PLANNING, ZONING, & BUILDING DEPARTMENT
PZ&B Staff Combination Memorandum: Architectural Commission and Town Council \

SUBJECT: ARC-23-052 (ZON-23-092) 300 COLONIAL LN (COMBO)

MEETING: DECEMBER 15, 2023 ARCOM
JANUARY 10, 2024 TC

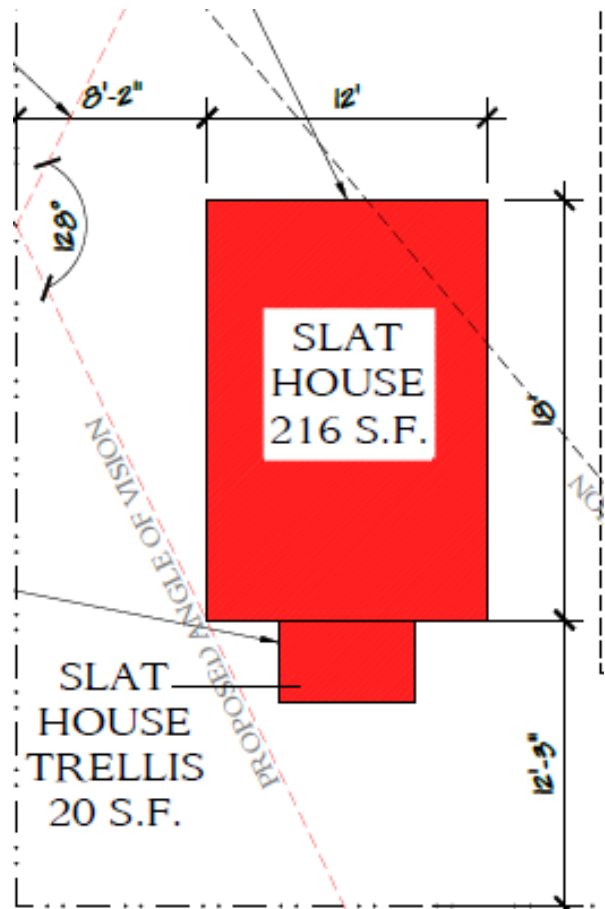
As the diagram to the right illustrates, **Variances 1** through **4** occur at the accessory slat house structure.

This structure is proposed to have a south rear yard setback of 8.75' at the 20 sq. ft. enclosed shower feature where 10' minimum setback is required for accessory structures (Variance 1).

At the west street-side yard setback, an 8.2' setback is proposed where a 25' street side-yard setback is required (Variance 2).

Due to the slat house structure's proximity to the primary structure (less than 25'), it must be included in the angle of vision calculation, pushing the angle of vision to 128° where 100° is the maximum permitted (Variance 3).

The slat house structure also pushes the lot coverage percentage over the maximum permitted (lot coverage variance not required due to size of primary structure) with 32% lot coverage proposed with 30% maximum permitted (Variance 4). A reduction in the size of the main house could be achieved to eliminate the need for the lot coverage variance, while retaining the slat house structure.

While the slat house is an attractive feature, and offers an airy or light massing due to its dual-sided, open-nature design, there is little compelling evidence submitted by the applicant justifying the hardship or practical difficulty criteria to exceed the lot yard and bulk requirements. In this regard, staff maintain that the new construction on a vacant parcel of land should meet these regulations.

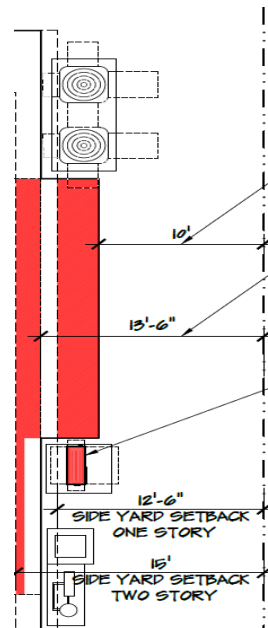
As the diagram to the right indicates, variances **5** through **7** are required due to project features at the east side yard area.

The primary structure is proposed to have a first-story east side-yard setback of 10' where 12.5' is the minimum setback required.

At the second story, the two-story side-yard setback is proposed at 13.5' where 15' is the minimum two-story side-yard setback required.

The east side-yard area is serving as the equipment yard area, and a third piece of A/C equipment is proposed in the setback where a maximum of two pieces of equipment is permitted. A/C equipment is permitted to be located within a side yard setback, with a 5' setback provided and a masonry screening wall to screen equipment from the neighboring property owners.
